Subject: Virgil C. Summer Nuclear Station (VCSNS) Units 2 and 3
Docket Numbers 52-027 and 52-028
Response to Requests for Additional Information related to Preservice Inspection
Requirements for Steam Generator Nozzle to Reactor Coolant Pump Casing
Welds Rev. 1 Supplement 1

Westinghouse LTR-PAFM-17-6, Rev. 0, NP-Enclosure 1 (Non-Proprietary) - Additional Information Regarding AP1000 Vogtle Units 3 & 4 and V. C. Summer Units 2 & 3 Steam Generator to Reactor Coolant Pump Suction Nozzle Weld Flaw Evaluation

**Additional Information Regarding AP1000 Vogtle Units 3 & 4 and V. C. Summer Units 2 & 3
Steam Generator to Reactor Coolant Pump Suction Nozzle Weld Flaw Evaluation**

Figure 1: Schematic of AP1000 Steam Generator and Reactor Coolant Pump Inspection Region

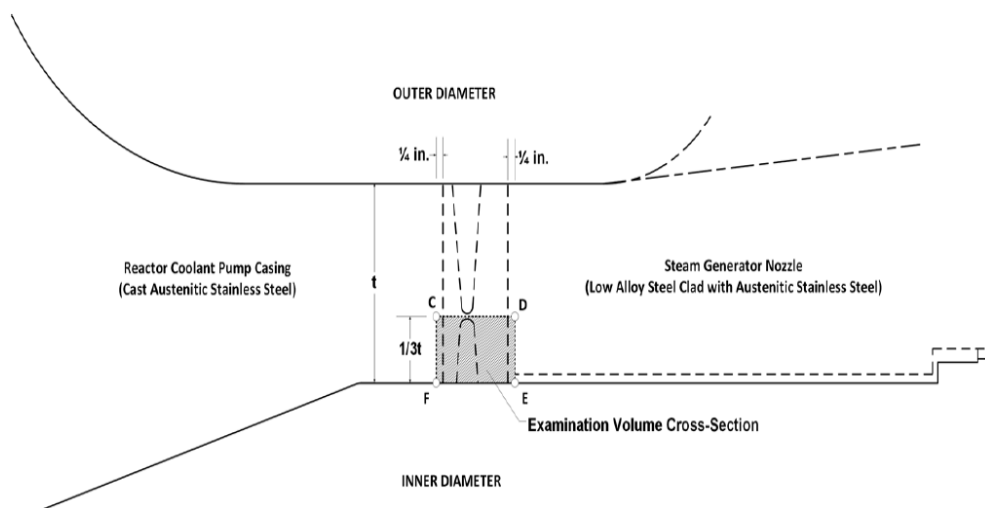
1. Additional information regarding justification of the constant flaw aspect ratios (AR) of 2 and 6 for axial and circumferential flaws in Reference 1 is provided below.

For the postulated axial flaw, the analysis in Reference 1 considers an $AR = 2$ (flaw length/flaw depth). This flaw shape is based on the understanding that in the DM (dissimilar metal) weld, the axial flaw will follow the characteristic shape of the DM weld width and thickness. The DM weld inspection volume consists of the width of the dissimilar metal weld and the Heat Affected Zone (HAZ) – see Figure 1. The width of the dissimilar metal weld is approximately []^{a,c,e} based on the AP1000 steam generator and pump drawings. The inspection volume includes the 1/4” examination zones adjacent to the weld on either side to account for the HAZ. Therefore, the total width of the DM weld inspection region is approximately []^{a,c,e}. The weld thickness is []^{a,c,e} (Reference 1). Therefore the shape or aspect ratio of the weld is 0.6 []^{a,c,e}, thus an aspect ratio of 2 is sufficiently large to account for any existing and hypothetical axial flaws.

For the postulated circumferential flaw, the analysis in Reference 1 considers $AR = 6$ (flaw length/flaw depth). This flaw shape is a typical aspect ratio for various applications in fracture mechanics. For instance, the Pressure Temperature (P-T) limits evaluation in ASME Section XI Appendix G also considers postulated flaw shapes to have an aspect ratio of 6:1. Industry experiences have also shown that the flaws found in-service are typically below $AR = 6$ (on the order of $AR = 2$ to 4 or even less). It should be noted that the AP1000 steam generator to pump DM weld region does not experience any high thermal stratification, as evident by the minimal fatigue usage discussed in Section 3 of Reference 1; therefore, there is low susceptibility for any fatigue crack initiations or propagation of existing fabrication indications. Therefore, the aspect ratio of 6 is sufficient to account for any existing and hypothetical circumferential flaws.

Also, based on the fabrication ultrasonic testing (UT) results, the flaw aspect ratios that are observed are bounded by the analyzed aspect ratio of 2 for axial flaws. For example, based on the available axial flaw UT results for the AP1000 Vogtle and V. C. Summer units, [

] ^{a,c,e} This particular
detected aspect ratio is bounded by the axial flaw aspect ratio of 2 analyzed in Reference 1.

Also, based on the fabrication ultrasonic testing results, the circumferential flaw aspect ratios that are observed are bounded by the analyzed aspect ratio of 6 for circumferential flaws. For example, based on the available circumferential flaw UT results for the AP1000 Vogtle and V. C. Summer units, [

particular detected aspect ratio is bounded by the circumferential aspect ratio of 6 in the analysis (Reference 1).
